**CLAY BED MODELING
ELIOT QUARRY- CEMEX AGGREGATES
ALAMEDA COUNTY, CALIFORNIA**

PREPARED BY: JEFF LIGHT, GEOLOGIST
P.G. #7661
JEFF LIGHT GEOLOGIC CONSULTING
15217 DE LA PENNA CIRCLE
RANCHO MURIETA, CA. 95683

DATE: DECEMBER 3, 2018

Figure 1. Comparison of the feet of clay logged divided by the total drill depth for the 2013, 86, 2012 and 2018 data. There appears to be no bias in percentage of clay logged between the different drilling and logging methods.

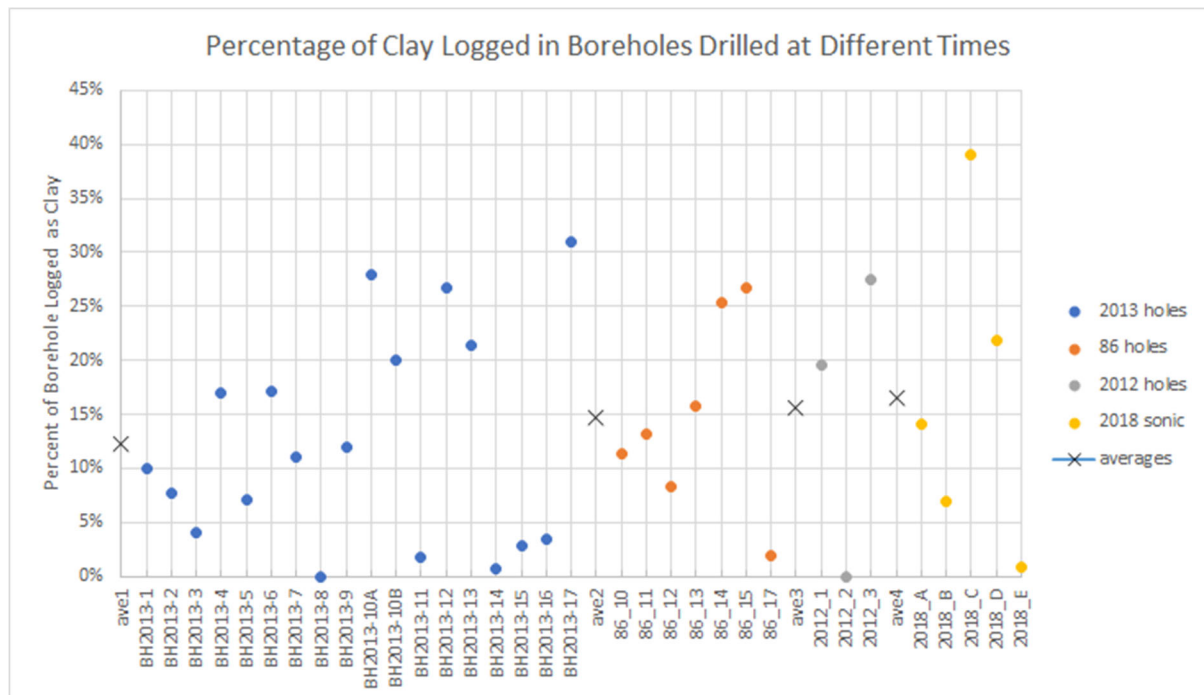
1. All of the borings drilled at the site are comparable relative to the percentage of clay encountered while drilling, independent of the drilling or logging methods used (Figure 1). However, Zone 7 does not include 21 Becker Hammer drill holes in their dataset, all of which are in the study area.

- Analysis of the logged feet of clay per feet of hole drilled for the 2013 Becker Hammer holes are similar to that logged in the most recent 2018 sonic holes. There is no reason to exclude those 21 holes from the dataset.

Figure 28.

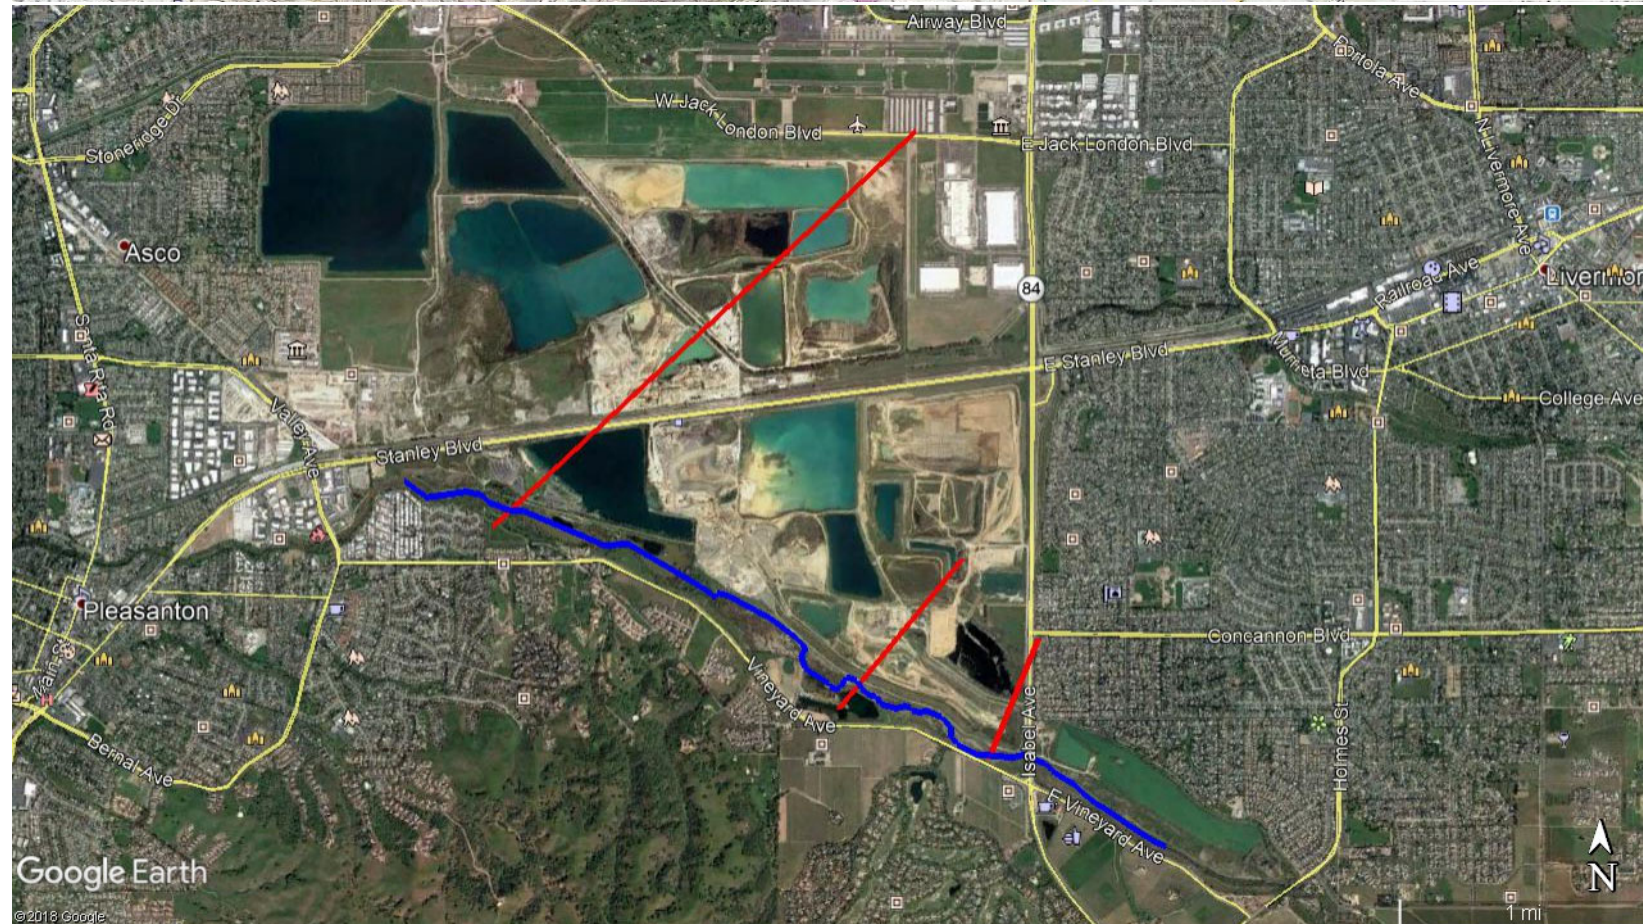
- Correlation of clays along the depositional strike should be relatively flat and that depositional strike should be roughly perpendicular to the stream and floodplain dip direction. Zone 7 clay correlation results in a clay deposit dip direction that is roughly 5 degrees east of north (Figure 26), that dip direction is rotated 60 degrees clockwise from the current stream and floodplain gradient observed in Arroyo del Valle (Figure 27 and 28).

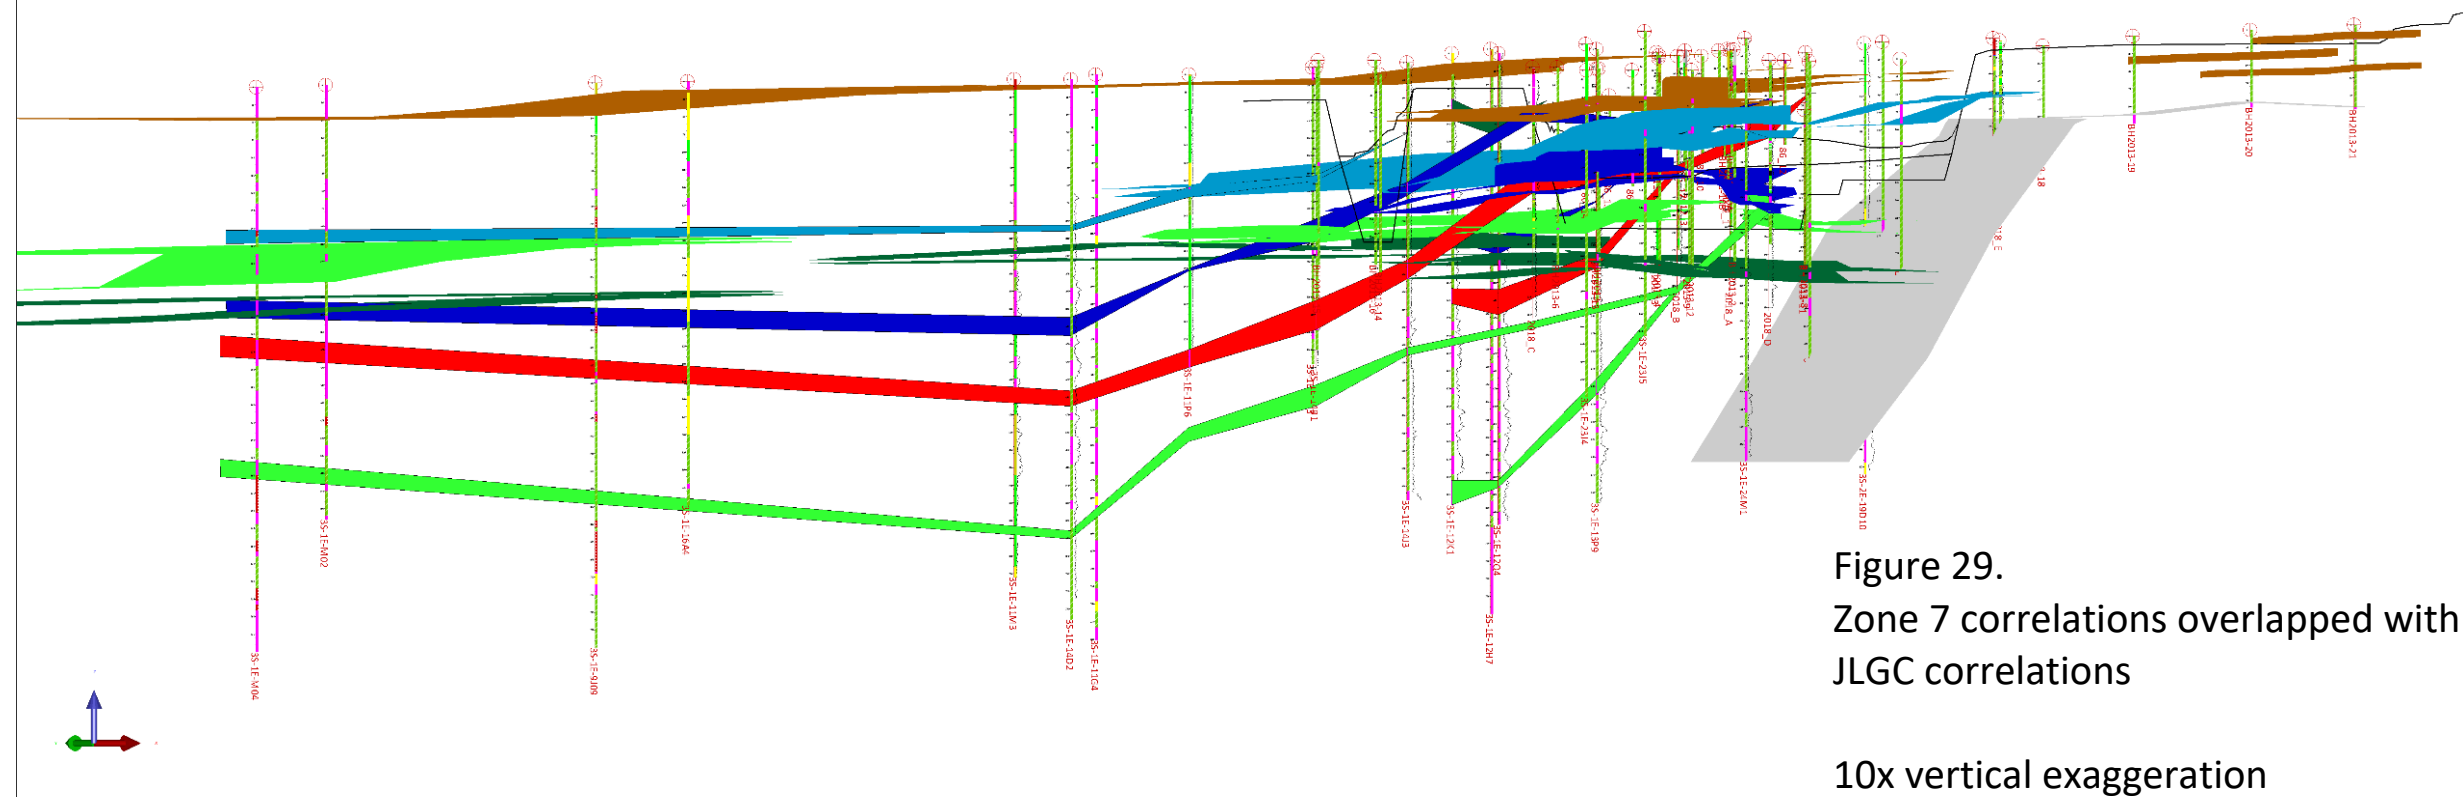
5. Zone 7 clay correlation is too steep, and is inconsistent with a braided stream depositional environment (Figure 25 and Figure 29).
- The angle at which the clays are connected in the Zone 7 interpretation are too steep. The Zone 7 correlation gradient of 3%-6% far exceeds the 0.2%-1% topographic gradient and 0.6% stream gradient observed within the Arroyo del Valle floodplain. Even with tectonic basin dropping as a potential effect on the dip of geologic units. The impact on beds that are only a few hundred feet below the surface should be minimal and the 400' drop in elevation along a single clay bed (Clays 6 and 7) starting at 100' below the current topographic surface seems very aggressive.
